UNITED STATES PATENT AND TRADEMARK OFFICE

APPLICATION NO.	FILING DATE	FIRST NAMED INVENTOR	ATTORNEY DOCKET NO.	CONFIRMATION NO.
10/586,693	09/08/2008	Johann Magg	2004P00165WOUS	8203

Office Action Summary	Application No. 10/586,693	Applicant(s) MAGG ET AL.	
	Examiner BRETT SPURLOCK	Art Unit 3742

DETAILED ACTION

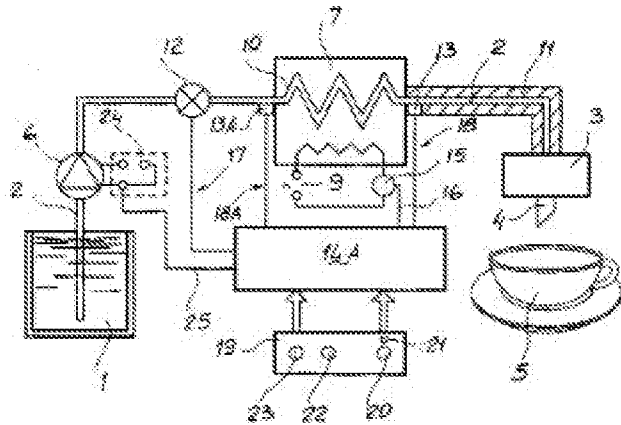
In Fig. 3, taken from Liverani as shown below, 13A is a first temperature sensor which is located at the inlet of the continuous water heater and 13 is a second temperature sensor located at the outlet of the continuous water heater. Clearly the first part of the limitation has been met.

Applicant proceeds to quote the sections of the Liverani which were cited in the previous Office Action. On page 12, within the section underlined, Applicant states that the "control device is programmed so as to process the signals received from the clock and the temperature sensor according to a given algorithm (**SIC**).” As can also be seen in Fig. 3, 18 and 18A respectively connect 13 and 13A to the controller 14A; special note should be paid to the fact that Liverani states that 18 and 18A are “the conductors that connect the temperature sensor to the control device (14).” Furthermore, as recited in column 4, lines 47-55 of Liverani:

The control system 14A allows various function modes for the machine. Of these modes at least 4 depend on the detection of the coffee machine function parameters (such as the flow of water in duct 2 controlled by means of the water delivery counter 12 and the water temperature measured at the exit of the heat exchanger and that may oscillate around the reference temperature as controlled by means of sensor 13). [SIC]

Applicant's arguments are not persuasive.
